MICROCHIP PIC16C63A/65B/73B/74B

PIC16C63A/65B/73B/74B Rev. A Silicon/Data Sheet Errata

The PIC16C63A/65B/73B/74B parts you have received conform functionally to the Device Data Sheet (DS30605C), except for the anomalies described below.

FIGURE 1: $\overline{\text{MCLR}}$ EXTERNAL CIRCUIT

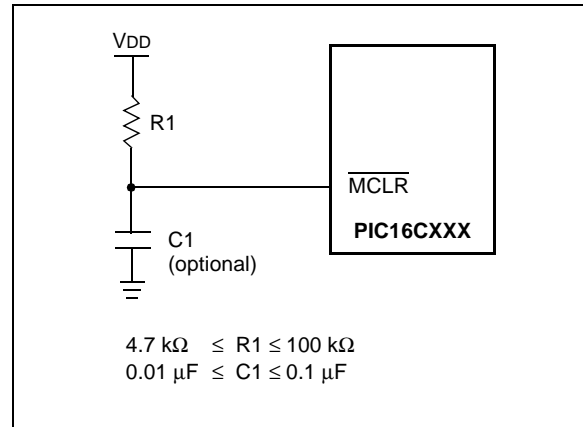
1. Module: RESET

The minimum specification for the $\overline{\text{MCLR}}$ must be met in order to reset the PIC16CXXX. If a $\overline{\text{MCLR}}$ pulse occurs that is less than the minimum specification (parameter #30), improper device operation can occur.

If the minimum specification cannot be met, then an external circuit must be used to ensure that any pulse width less than the specification will be filtered before it reaches the $\overline{\text{MCLR}}$ pin.

A possible circuit is shown in Figure 1. This circuit works by delaying the $\overline{\text{MCLR}}$ release following a power-up. If no delay is required, the capacitor may be omitted.

An alternative would be to use a supervisory circuit to control $\overline{\text{MCLR}}$.

Design validation should be performed to verify that the application works as expected.

FIGURE 2: WAKE-UP FROM SLEEP

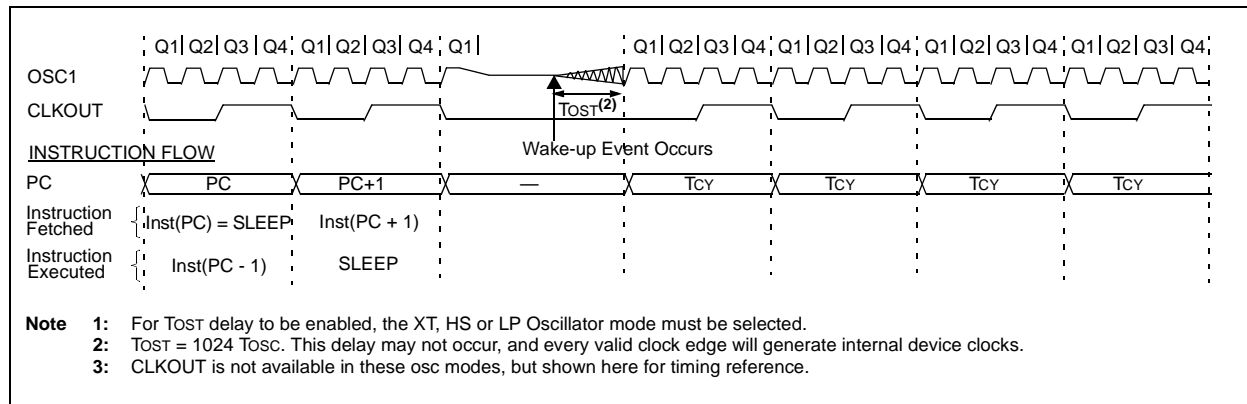
2. Module: OSCILLATOR

The Oscillator Start-up Timer (TOST) delay may not occur when the device wakes up from SLEEP.

Figure 2 shows the start-up of the crystal after the event that causes the device to wake-up from SLEEP mode (as specified in device data sheet). The start-up time (TOST) may not occur.

After the SLEEP instruction, do a software delay of 256 T_{CY} (same as 1024 T_{OSC}). At the RESET and Interrupt vector addresses, test to see if the device woke from SLEEP (the \overline{TO} and \overline{PD} bits), and if the device did wake from SLEEP, ensure that the total cycle delay is 256 T_{CY}.

FIGURE 10-1: SSP BLOCK DIAGRAM (SPI MODE)

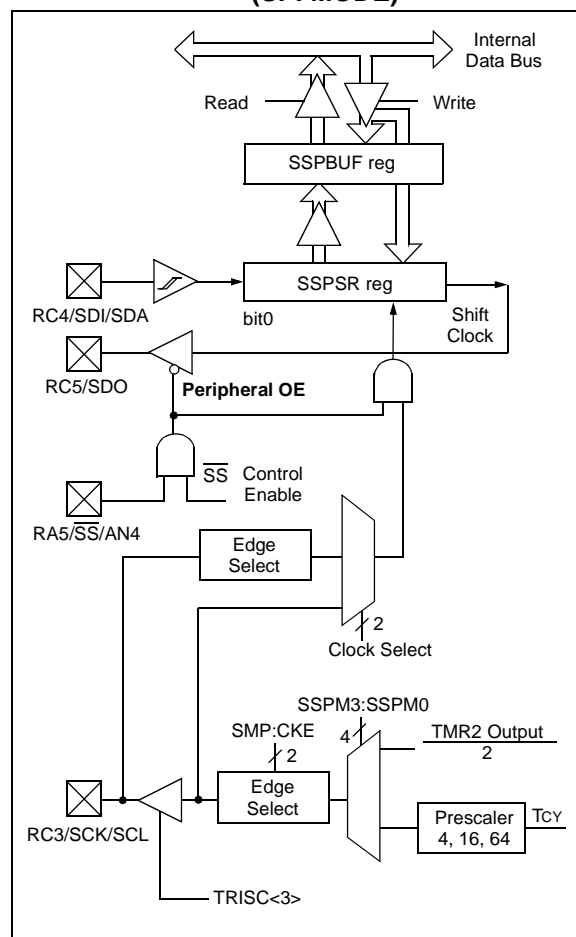
In Section 10.2 ("SPI Mode"), Figure 10-1 and the note box immediately beneath it have been amended to better demonstrate the Peripheral OE line of the SSP module and describe its relationship to the TRISC<5> bit of PORTC.

Changes are indicated in **bold**.

3: When the SPI is in Slave mode with \overline{SS} pin control enabled ($SSPCON<3:0> = 0100$), the state of the \overline{SS} pin can affect the state read back from the TRISC<5> bit. The Peripheral OE signal from the SSP module into PORTC, controls the state that is read back from the TRISC<5> bit (see Section 5.3 for information on PORTC). If Read-Modify-Write instructions, such as **BSF**, are performed on the TRISC register while the \overline{SS} pin is high, this will cause the TRISC<5> bit to be set, thus disabling the SDO output.
